PCN-20201005 TE0710-02 DDR Change

Company	Trenz Electronic GmbH
PCN Number	PCN-20201005
Title	TE0710-02 DDR Change
Subject	BOM change
Issue Date	2020-10-06

This change affects all Trenz Electronic TE0710 modules of revision 02 with industrial assembly variants TE0710-02-*-*I*.

#1 Change DDR Flash from IM4G08D3FABG-125 to IS43TR85120BL-125KBLI

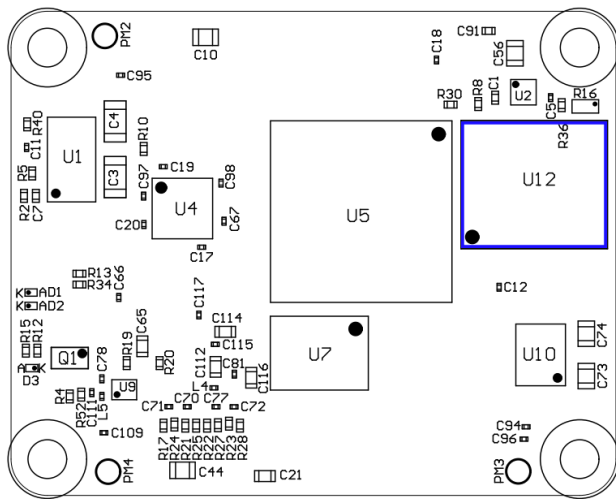
Reason: Old DDR was not specified for industrial temperature range.

Impact: New timings may be considered for existing designs.

Locate DDR (U12) at top side of PCB:
